DEVELOPMENT REVIEW BOARD REPORT

MEETING DATE: June 9, 2005

CASE NUMBER/ PROJECT NAME	20-DR-2005 Town Center Commercial (@ DC Ranch)		
LOCATION	10375 E Horseshoe Canyon Drive		
REQUEST	Request approval of a site plan, elevations, landscape plans, & wall plans for a Planned Commercial Center (PCC) located within the Town Center at DC Ranch, which will include retail, restaurants, and offices.		
OWNER	D M B Associates, Inc. 480-367-7000	ENGINEER	Wood, Patel & Associates, Inc. 602-335-8500
ARCHITECT/ DESIGNER	H & S International 480-585-6898	APPLICANT/ COORDINATOR	Shelly McTee Biskind Hunt & Taylor 602-955-2328
BACKGROUND	<p>Zoning. DC Ranch is a master planned community. The site is zoned Planned Community Center/Planned Community District (PCC/PCD). The PCC/PCD zoning district allows a larger variety of commercial activities to serve a larger segment of population than a typical neighborhood shopping center.</p> <p>Context. This site is located at the northeast corner of Union Hills Drive and Thompson Peak Parkway intersection, within DC Ranch's Town Center, planned for a mixed-use development. Single-family homes are planned adjacent to the north and east of the property, and also

CONCEPTUAL LANDSCAPE AND WALL PLAN

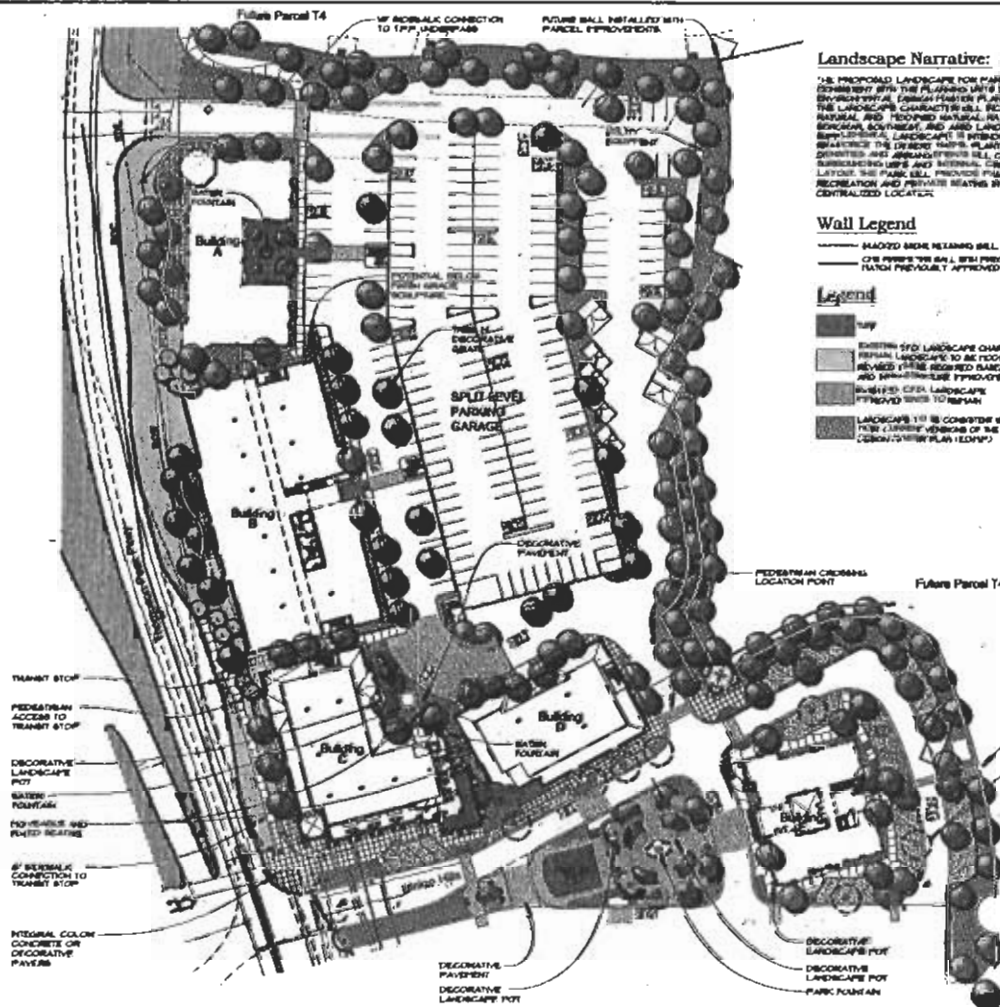
- c. Landscaping, including quantity, size, and location of materials shall be installed to be consistent with the conceptual landscape plan submitted by Vollmer & Associates with a preparation date of 3/13/2005 and a staff receipt date of 6/01/2005.

10. Upon removal of the salvageable native plants the salvage contractor shall submit completed Native Plant Tracking Form as well as a list identifying the tag numbers of the plants surviving salvage operations to the City's Inspection Services Unit within 3 months from the beginning of salvage operations and/or prior to the issuance of the Certificate of Occupancy.

BUILDING "E" ELEVATIONS

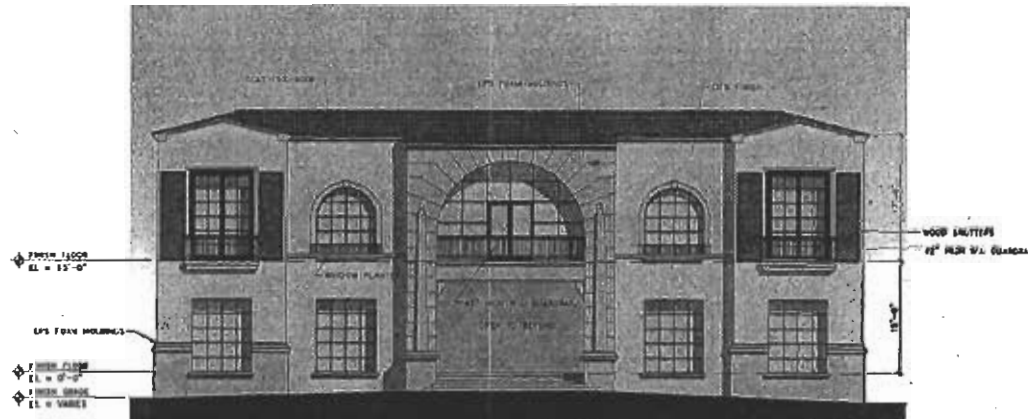
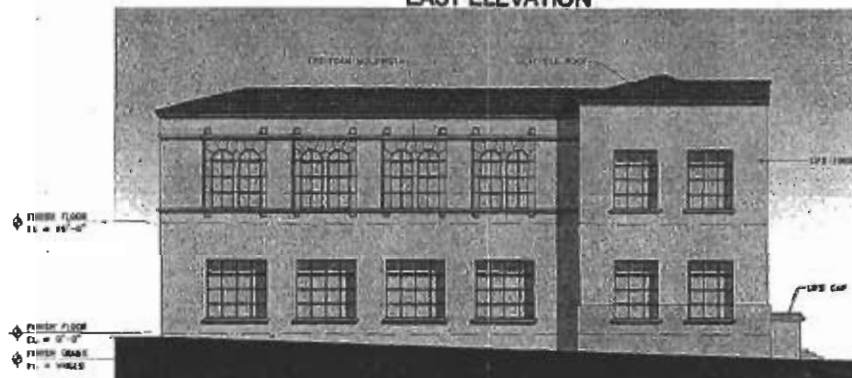
- a. Architectural elements, including dimensions, materials, form, color, and texture, shall be constructed to be consistent with the building elevations submitted by H&S International with a preparation date of 3/4/2005 and a staff receipt date of 6/01/2005.
